To: Kristopher Byrd, Well Construction Section Manager
From: Tommy Laird, Well Construction Program Coordinator
Subject: Review of Water Right Application G-19229
Date: February 27, 2024

Application # G- 19229

GW Reviewer Gabriela Ferreira / Dennis Orłowski Date Review Completed: October24, 2023

Well Location Map

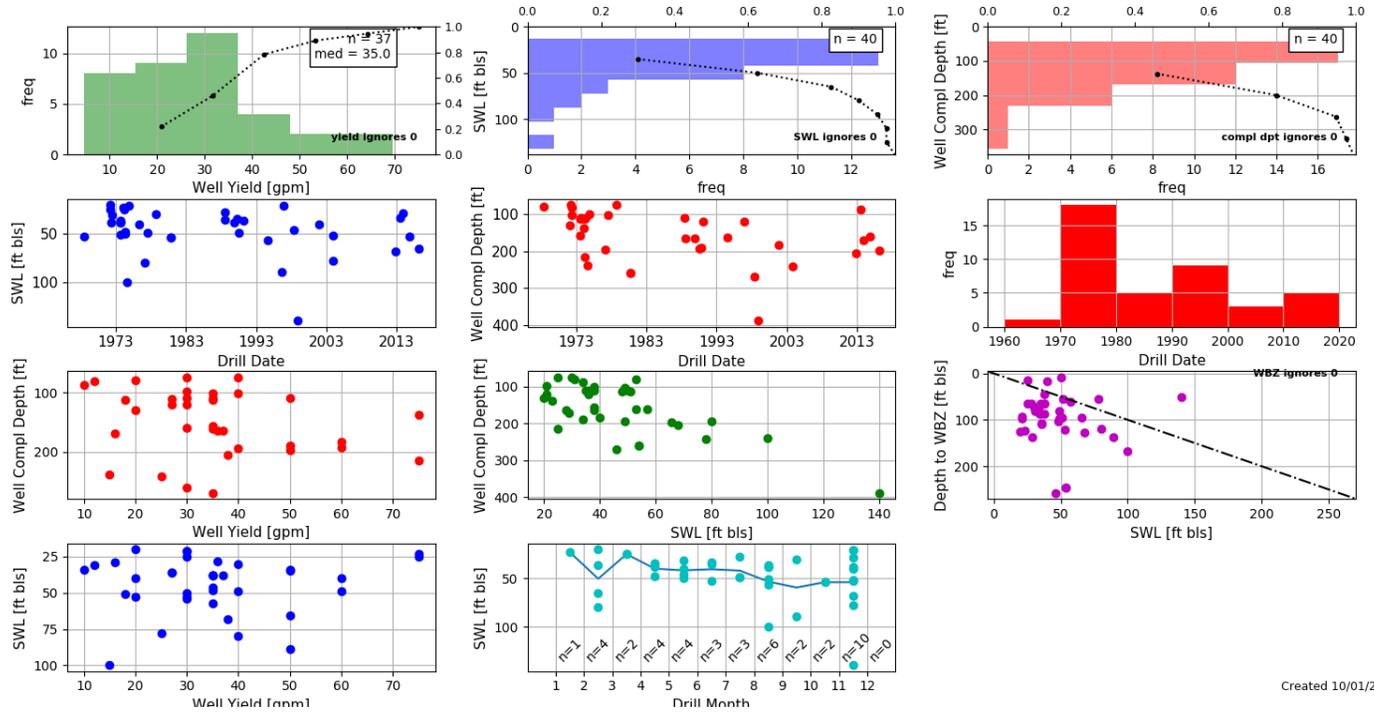
B3. **Groundwater availability remarks:** The proposed POAs are located in the central Willamette Valley and will produce from water-bearing sand and gravel layers within the Willamette Confining Unit, estimated to be approximately 600 feet thick (Gannett and Caldwell, 1998). Bedrock (Columbia River Basalt group) is encountered approximately 600 feet below land surface (bls). The majority of wells in the immediate vicinity draw water from the upper Willamette Confining Unit (see attached well statistics).

Within approximately one mile of the proposed POA locations, there are about seven groundwater PODs, for irrigation and nursery use, completed in the alluvial aquifer system, with several more exempt (domestic) wells also likely in the area. Reported maximum yields at time of drilling from nearby alluvial wells (mostly domestic) typically range up to 100 gpm. Well deepenings are not prevalent. Pump test from nearby groundwater PODs reported yields of less than 50 gpm (CLAC 12188, CLAC 12181, CLAC 69332, CLAC 52274) with only one reporting a yield of 120 gpm (CLAC 12088). The requested rate (0.41 cfs / 186 gpm) is within the upper range of yields reported for nearby wells.
